## DEVELOPMENT APPLICATION ASSESSMENT REPORT

<b>Application Number:</b>	DA2020/1194
----------------------------	-------------

<b>Responsible Officer:</b>	Gareth David
<b>Land to be developed (Address):</b>	Lot 55 DP 11462, 61 Dress Circle Road AVALON BEACH NSW 2107
<b>Proposed Development:</b>	Alterations and additions to a dwelling house
<b>Zoning:</b>	E4 Environmental Living
<b>Development Permissible:</b>	Yes
<b>Existing Use Rights:</b>	No
<b>Consent Authority:</b>	Northern Beaches Council
<b>Land and Environment Court Action:</b>	No
<b>Owner:</b>	Haidee Anna Keegan
<b>Applicant:</b>	Jamie King Landscape Architect

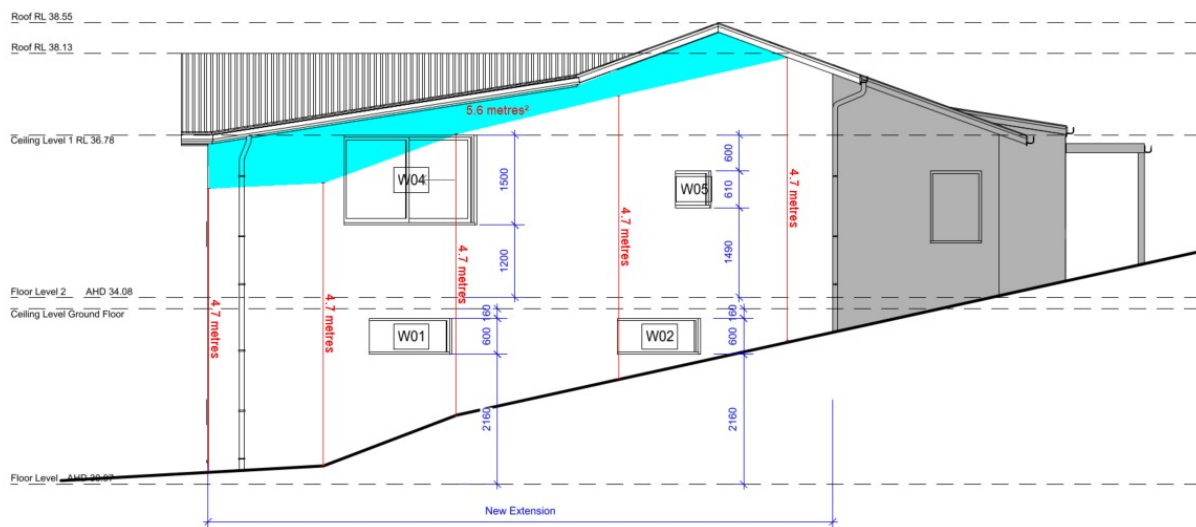
Additionally, within Development Application N0133/12 approved 2 July 2012, this proposed hardstand area was approved as landscaping in order to minimise the impact of the built form of the approved swimming pool within the front setback. The location of this hardstand area within the front setback would remove opportunity for vegetation and landscaping to visually reduce the built form of this existing raised swimming pool within the front setback.

Moreover, a 1.8m front fence has been constructed along the Dress Circle Road frontage of the property. Similarly, this fence does not appear to meet the relevant exempt development standards under State Environmental Planning Policy (Exempt and Complying Development Codes) 2008 and a review of Council's records failed to locate any development consent for these works. As such, Council does not consider an unauthorized fence to form justification for the screening of structures within the front setback.

This does not form a reason to refuse the application. In this instance, a condition of consent will be included to remove the driveway and hardstand located off Dress Circle Road from all plans and for the plans to incorporate landscaped area directly on the front setback to replace the proposed parking area.

a) The hardstand parking space and associated driveway located off Dress Circle Road, adjacent to the swimming pool, is to be deleted from all plans.

b) In the location of the deleted hardstand and driveway located off Dress Circle Road, a landscaped area capable of deep soil planting is to be provided.
